AMENDMENT OF SOLICITATION/MODIFICATION OF CONTRACT			1. CONTRACT ID CODE	PAGE 1 OF 9 PAGES
2. AMENDMENT/MODIFICATION NO. 0003	3. EFFECTIVE DATE 07/03/00	4. REQUISITION/PURCHASE REQ. NO. 351-0-0944	5. PROJECT NO. (if applicable)	
6. ISSUED BY NAT.INST.OF STANDARDS & TECHNOLOGY ACQUISITION & ASSISTANCE DIVISION BUILDING 301, ROOM B117 100 BUREAU DRIVE, STOP 3572 GAITHERSBURG, MD 20899-3572		7. ADMINISTERED BY (If other than Item 6)		
8. NAME AND ADDRESS OF CONTRACTOR (No., street, county, State and ZIP code) TO ALL OFFERORS			9A. AMENDMENT OF SOLICITATION NO. 52SBNB0C1045	
			9B. DATED (SEE ITEM 11) 05/19/00	
			10A. MODIFICATION OF CONTRACT/ORDER NO.	
			10B. DATED (SEE ITEM 13)	
CODE	FACILITY CODE

Project Title	NIST
Sheet Title	15KV ELECTRICAL DISTRIBUTION CAMPUS SITE PLAN

The purpose of this Award Fee Determination Plan (AFDP) is to set forth the basic procedures and criteria for the periodic evaluation of, and award fee determination for, the construction of the Advanced Measurement Laboratory (AML), National Institute of Standards and Technology (NIST), Gaithersburg, MD.

Reference Sheet	E0-02
Amendment Number	3
Am. Drawing	AM-3-A/E0-02

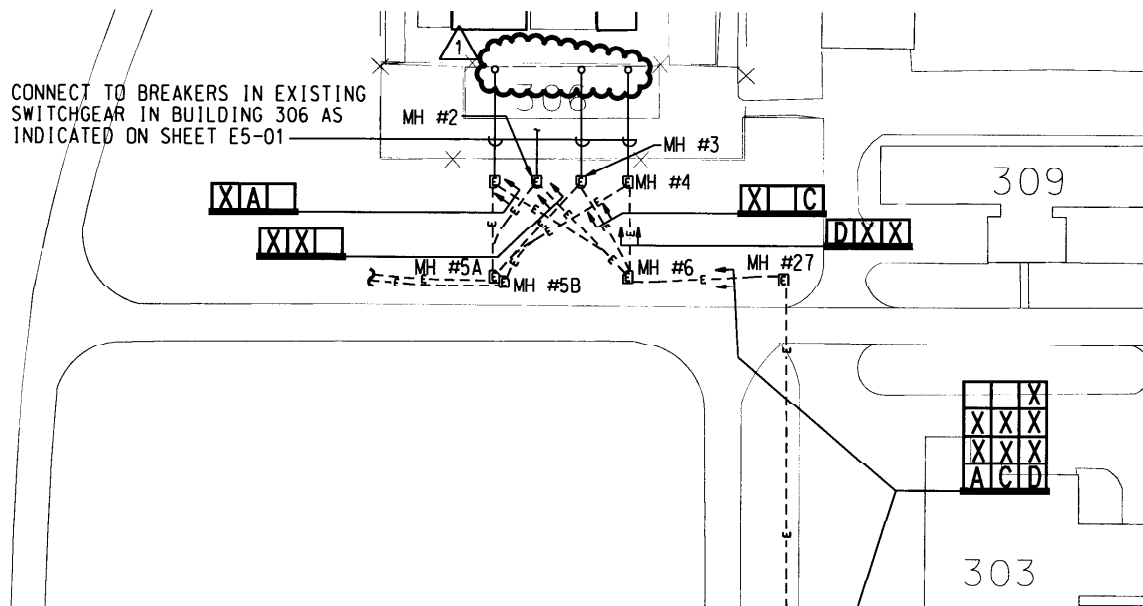
Entering water temperature should be 0.0 degC, instead of blank, for CC-103B, CC-104B, CC-201B, CC-203B, CC-204B, and CC-209B.
 4. Sheet No. E0-02 – 15 kV Electrical Distribution Campus Site Plan

Revise Plan as indicated on attached Amendment Drawing No. AM-3-A/E0-02.

Am. Drawing
AM-3-A/E5-17

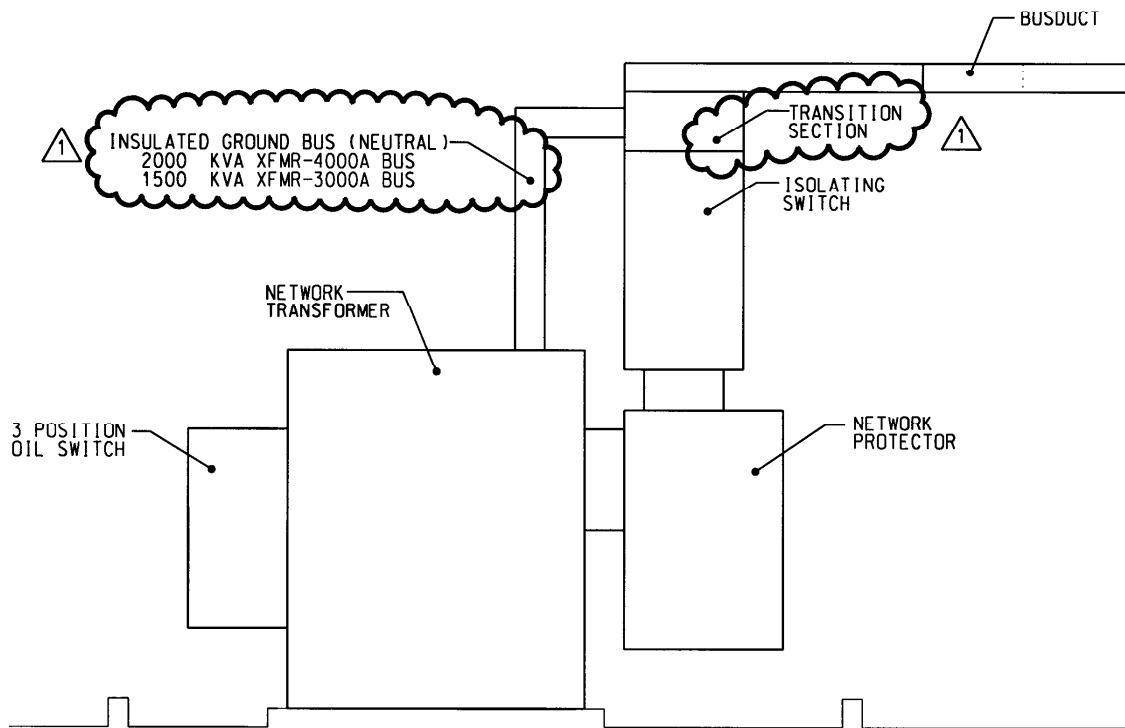
10. Sheet No. E5-17 – Substation Details and Schedules

Revise Typical Transformer and SwitchGear Section as indicated on Amendment Drawing No. AM-3-A/E5-17.

Figure 1. AML BACnet base bid network architecture.

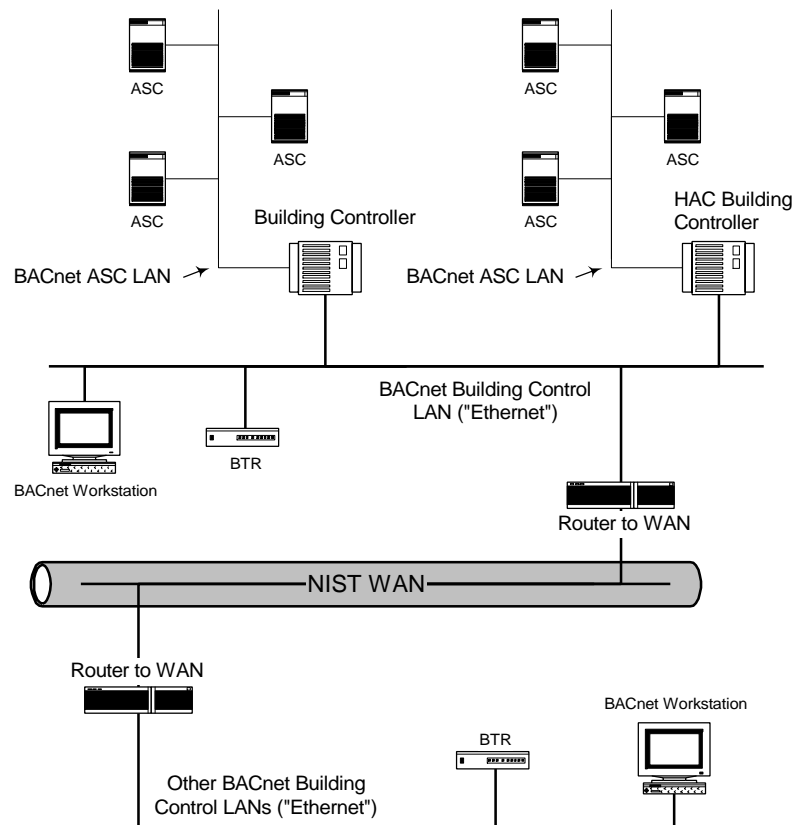
The following is offered as a clarification to current specification requirements for the provision of a native BACnet control system for the AML project:

Native BACnet HVAC controls system communications protocol shall be used for all HVAC controls within the building with the possible exception of the High Accuracy Controls (HAC) (+/- 0.01 and +/- 0.1 deg C) laboratories, which may utilize a proprietary (non-BACnet) system. HAC lab communication with the native BACnet building control LAN may be through the use of native BACnet control systems or through the use of a BACnet gateway device. Requirements for BACnet gateway devices are provided in paragraph 3 below. A building controls architecture diagram is provided in Figure 1 below for further clarification.

Figure 2. AML BACnet gateway alternate network architecture.

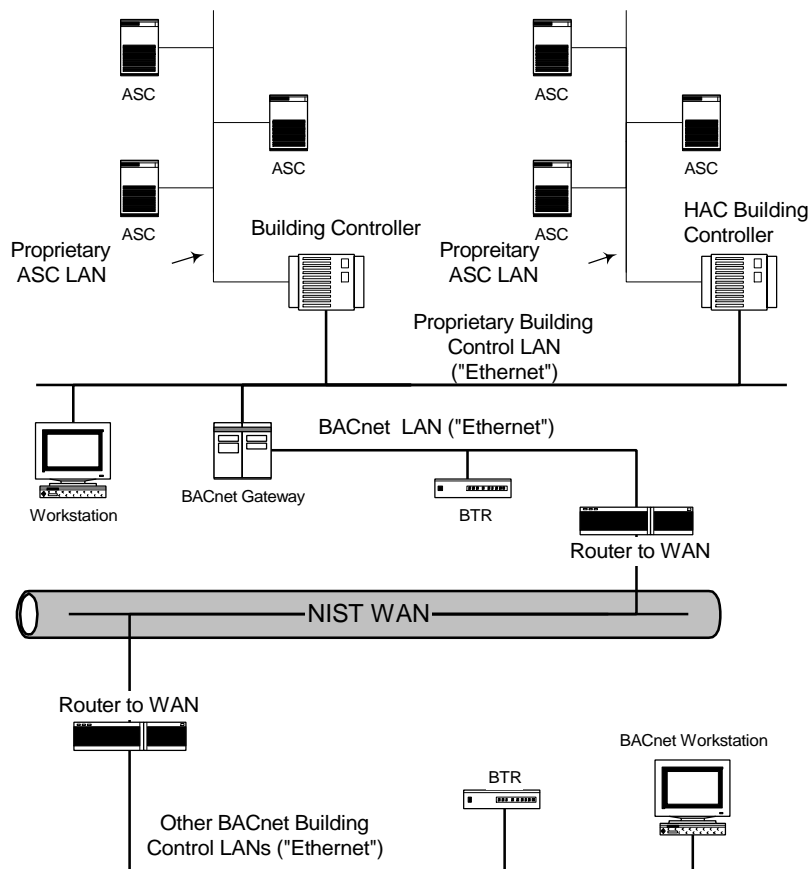
The following is offered as a clarification to the introduction of Offer Option 15 (CLIN 0023) for the provision of a non-native BACnet control system for the AML project:

Offeror shall provide pricing for the deletion of the requirement to use native BACnet communication and to substitute the use of proprietary HVAC controls communications networks incorporating BACnet gateway device(s) into the system for communication with a NIST site-wide network. Pricing proposed for this option shall be the differential cost between Base Price CLIN 0003 and that same Item with the provision of a proprietary (non-BACnet) system capable of communicating with a BACnet compliant NIST site-wide system. The use of a BACnet gateway device is allowable under this option; however, if communication requirements are met, the same system may be proposed under both the Base Offer Item and this Option Item. Communications requirements for the High Accuracy Controls (HAC) (+/- 0.01 and +/- 0.1 deg C) laboratories remain unchanged from that described under Base Price CLIN 0003. Requirements for BACnet gateway devices are provided in Paragraph 3 below. A building controls architecture diagram is provided in Figure 2 below for further clarification.
